Access Compliance Report Public Rights-of-Way (Curb Ramps)

Intersection ID: 14629 Main Street: EASTWAY DR Cross Street: WOODLAND DR Location: NW **Overall Compliance: No Severity Score:** 10 ADA ID: 0FB164DC56BC Ramp Type: PerpDiag Initial Pass/Fail: Fail

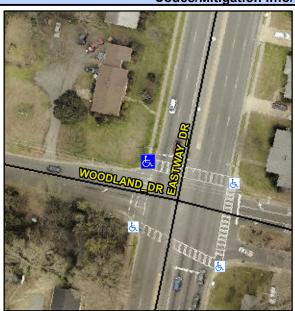
| | | | | 14/74 |
|-----------------|----------------|------|---------|-------|
| Not Found, | R304.5.1, R304 | .5.3 | | N/A |

WOODLAND DR Street 1 Name Stop Condition-Street 2 Signal **EASTWAY DR** Street 2 Name Stop Condition-Street 1 Signal Remove & Replace Curb Ramp With Two New Directional Ramps or Equivalent.
